**STAFF RECOMMENDATION**  
**2507 Barton Avenue**  
**January 20, 2021**

**Application:** New Construction—Addition  
**District:** Hillsboro-West End Neighborhood Conservation Zoning Overlay  
**Council District:** 18  
**Base Zoning:** RS7.5  
**Map and Parcel Number:** 10411025300  
**Applicant:** Blaine Bonadies, Architect  
**Project Lead:** Sean Alexander, sean.alexander@nashville.gov

<p><b>Description of Project:</b> A proposal to construct a ridge-raise and rear addition to an historic house. The addition will match the width of the historic house on the right side but will be six feet, four inches (6'-4") wider to the left.</p> <p><b>Recommendation Summary:</b> Staff recommends approval of the proposed addition with the following conditions:</p> <ol style="list-style-type: none"><li>1. Additional information about the foundation material and cladding is approved prior to construction; and</li><li>2. The window and door selections are approved prior to purchase and construction.</li></ol> <p>With these conditions, staff finds that the proposal will meet the design guidelines for new construction in the Hillsboro-West End Neighborhood Conservation Zoning Overlay.</p>	<p><b

Figure 1: 2507 Barton Avenue

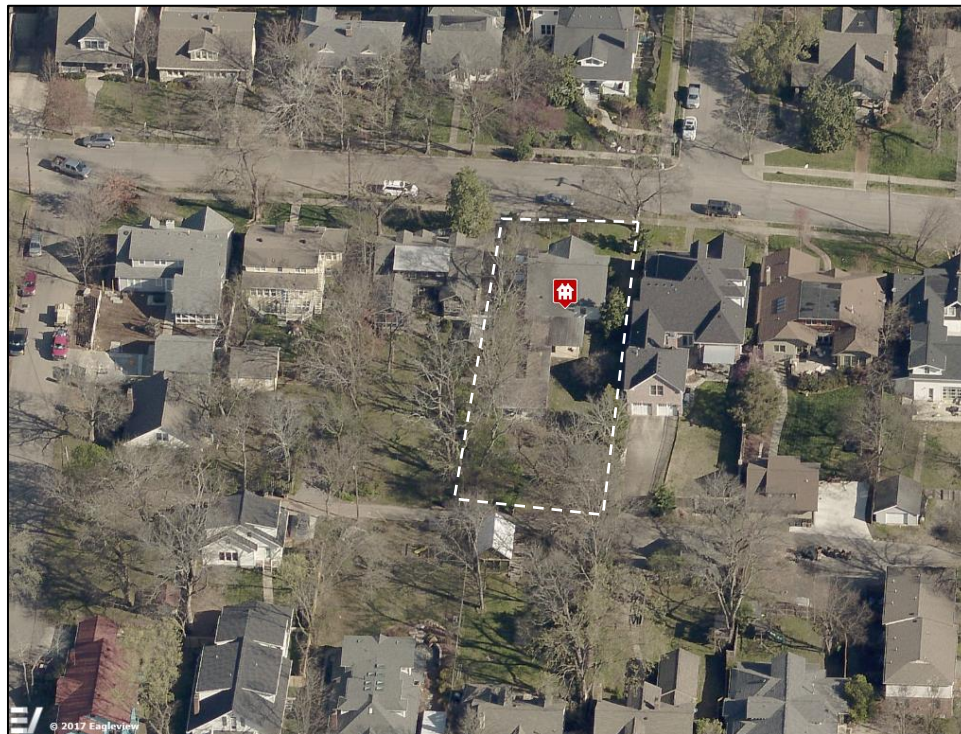
**Background:** The structure at 2507 Barton Avenue is a one-story Craftsman style house, constructed circa 1925. The house is contributing to the historic character of the district because of its age and architectural character.

**second floor plan**

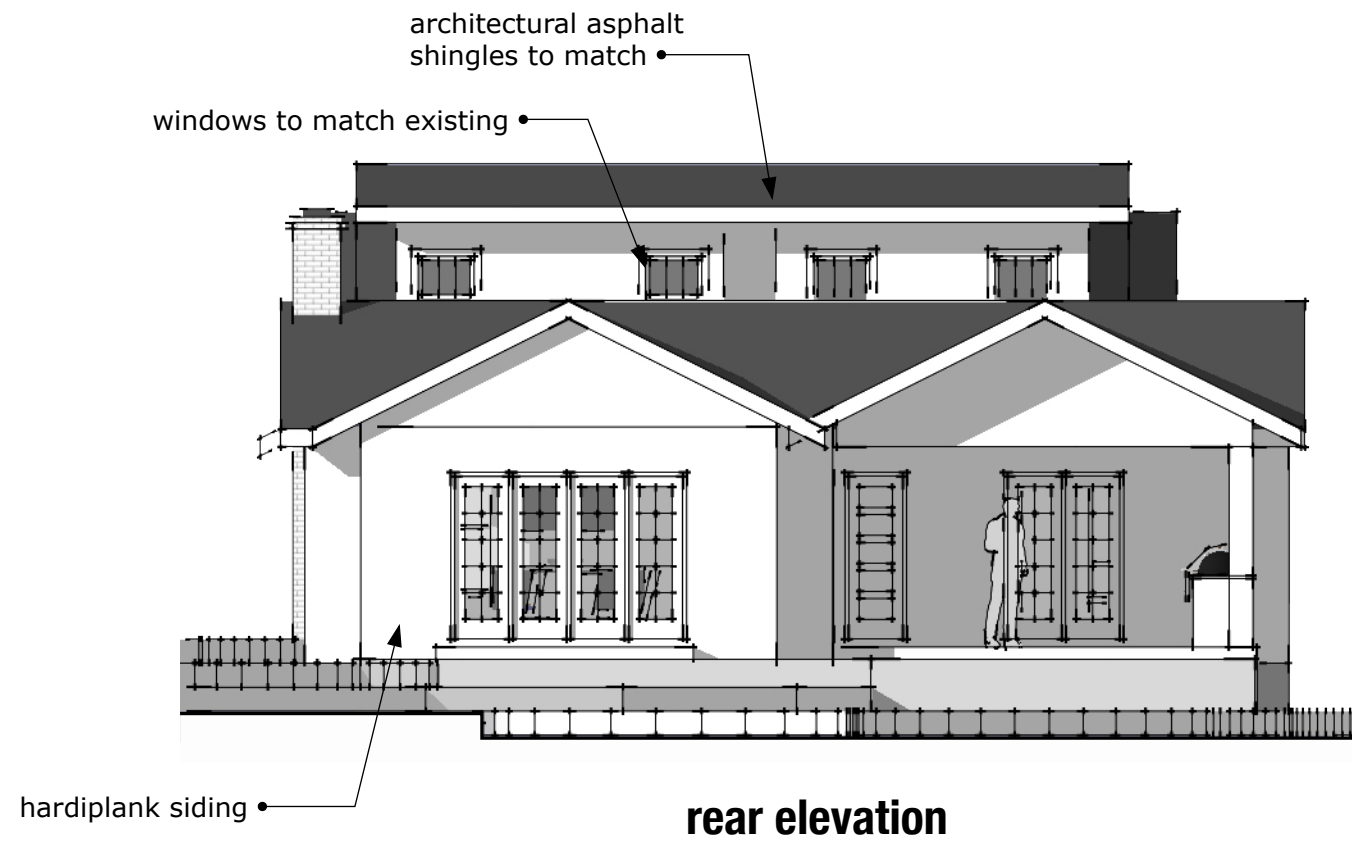
Height & Scale: A portion of the existing roof-ridge will be raised two feet (2'), stepped in two feet (2') from the sides of the house. This is consistent with previously approved additions on side-gabled houses.

On the first story, the addition will step in two feet (2') before extending back and stepping out wider. After a span of five feet (5'), the right side will step back out to align with the primary wall of the house, then after another seventeen feet (17') back it will bump out again to match the width of an original projecting bay on the right side of the house.

On the left side, after stepping in two feet (2') and extending back nine feet (9') the addition will step out six feet, four inches (6'-4") beyond the side of the historic house. Staff finds the additional width to be appropriate because the house is shifted to one side of the lot, and because the wider addition is significantly shorter than the historic house and a single-story form.

Staff finds the height and width of the proposed addition to be subordinate and to meet Sections II.B.1.a. and II.B.1.b. of the design guidelines.

**left elevation**

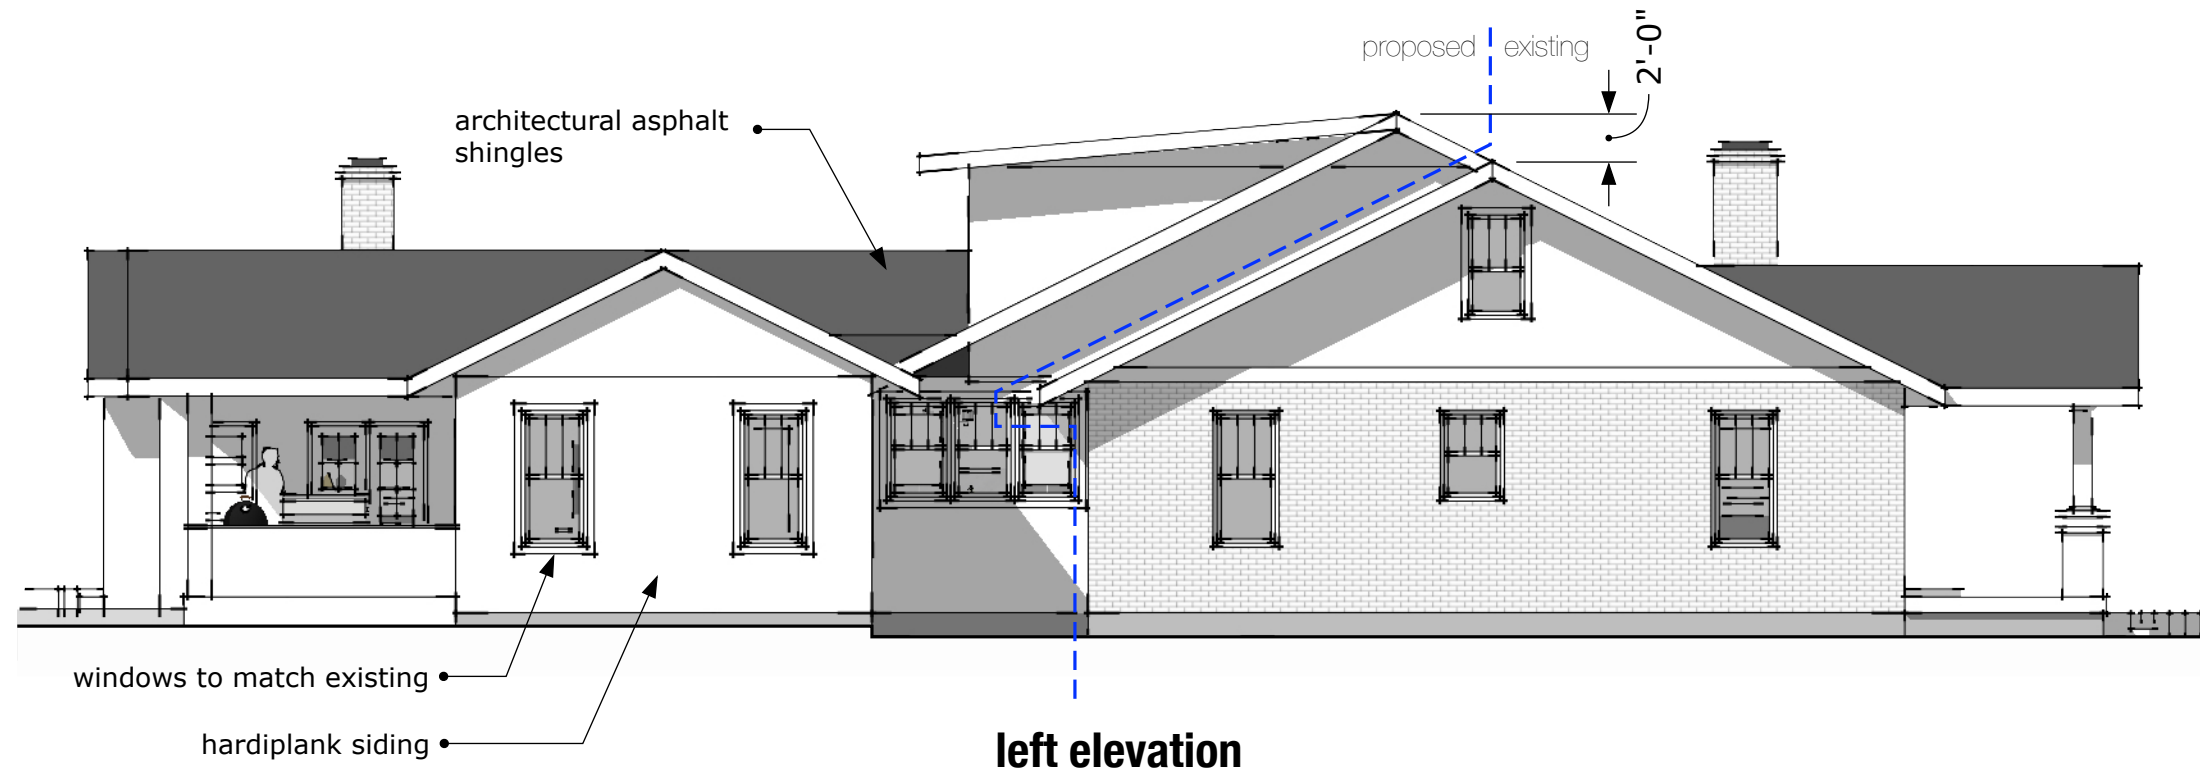
Setback & Rhythm of Spacing: The addition is stepped in two feet (2') from both sides of the historic house before extending back, then going wider to the left. The wider addition will not have a significant impact on the rhythm of spacing on the street, as the additional width occurs more than eighty-five feet (85') back from the right-of-way.

Staff finds that the setbacks of the proposed addition are appropriate and meet Section II.B.1.c. of the design guidelines.
